## City of Phoenix

### ADDENDUM A

Staff Report: PHO-1-19--Z-165-06-7(8)

June 25, 2020

Site Plan date stamped May 26, 2020

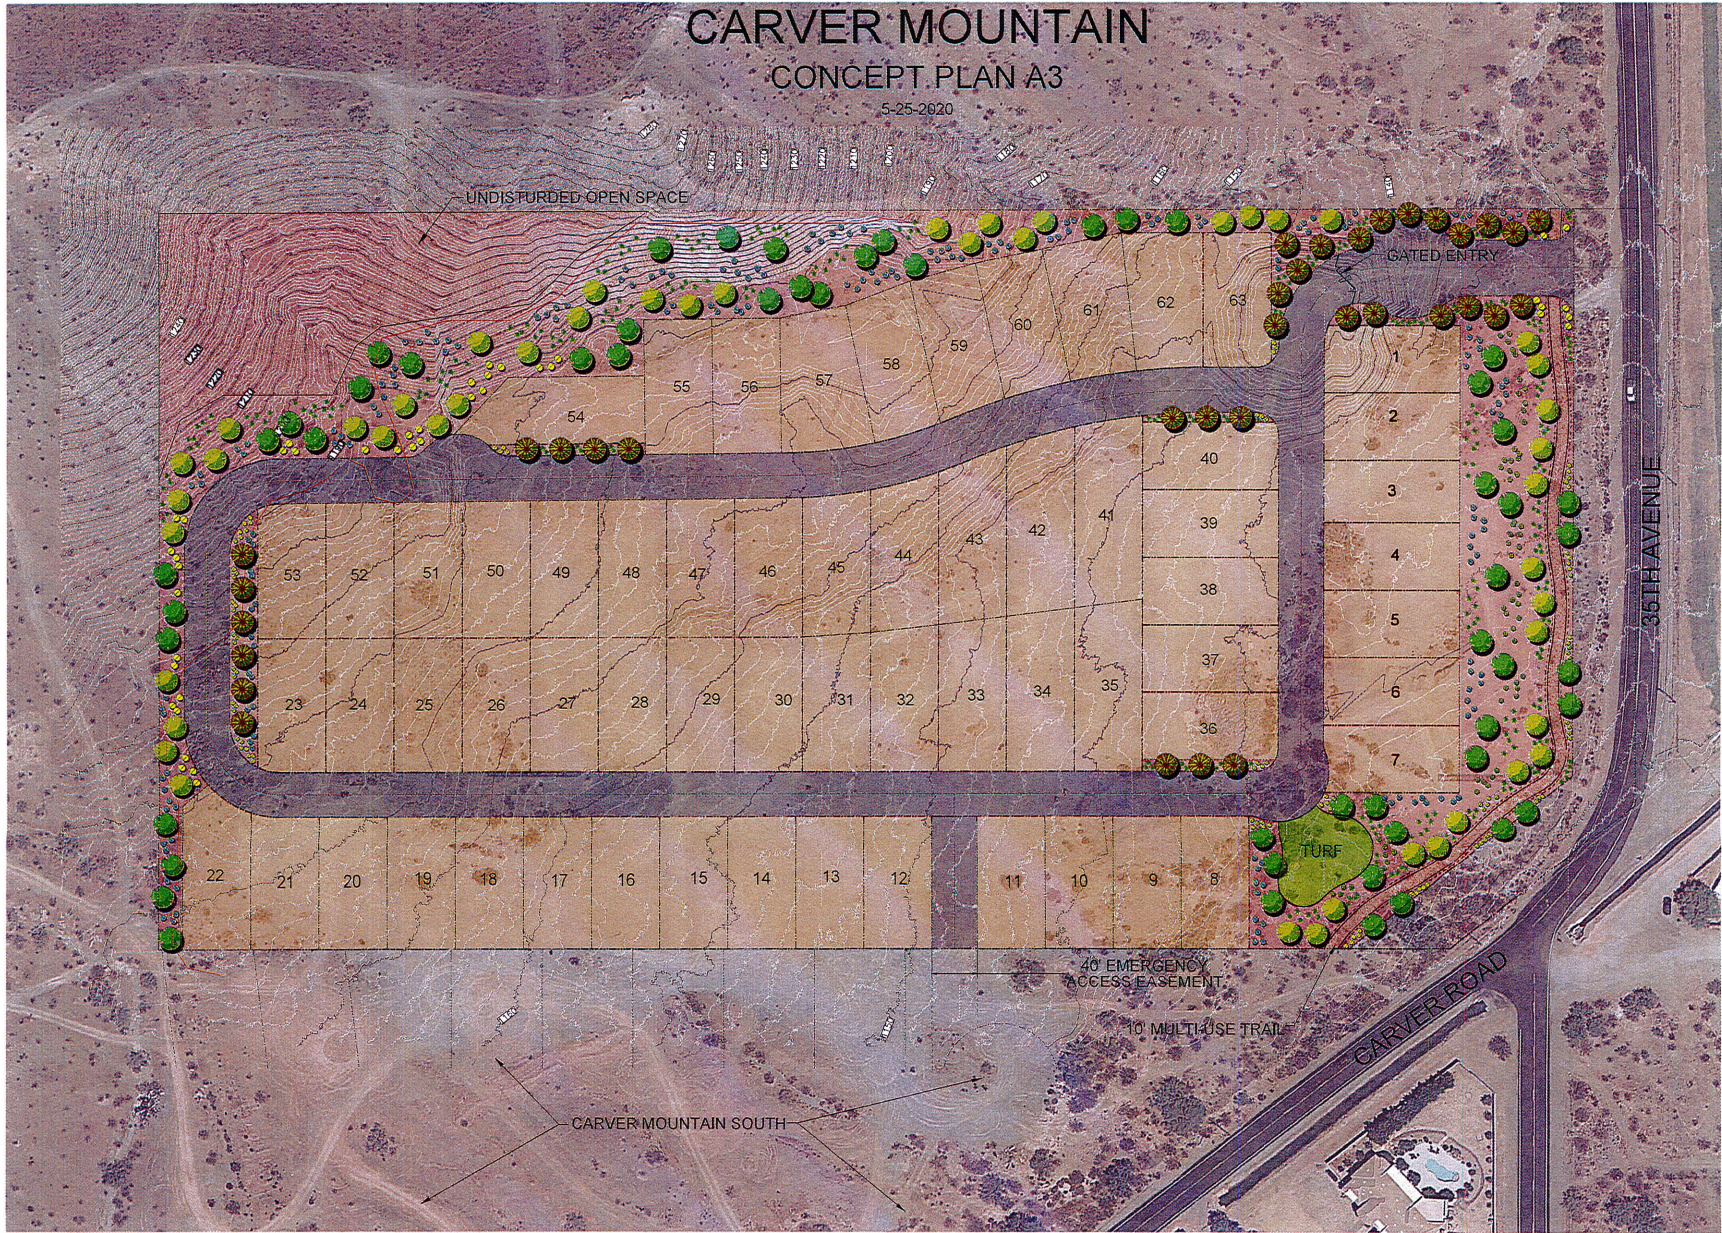
The applicant met with community members and revised their plan from 92 lots as shown on the site plan date stamped November 21, 2019 to 63 lots as shown on the site plan date stamped May 26, 2020. The changes on the revised site plan required modifications to the stipulations recommended by the PHO.

1. THE R1-8 DEVELOPMENT SHALL BE IN GENERAL CONFORMANCE WITH THE SITE PLAN DATE STAMPED ~~NOVEMBER 21, 2019~~ MAY 26, 2020, AS MODIFIED BY THE FOLLOWING STIPULATIONS AND APPROVED BY THE PLANNING AND DEVELOPMENT DEPARTMENT, AND WITH SPECIFIC REGARD TO THE FOLLOWING:

- ~~39.~~ That only one-story homes shall be located along 35th Avenue.  
47. LOTS ~~52-61 AND 82-83~~ 1-7, LOCATED ALONG 35TH AVENUE AND AS DEPICTED ON THE SITE PLAN DATE STAMPED ~~NOVEMBER 21, 2019~~ MAY 26, 2020, ARE LIMITED TO A MAXIMUM BUILDING HEIGHT OF 20 FEET, AS APPROVED BY THE PLANNING AND DEVELOPMENT DEPARTMENT.
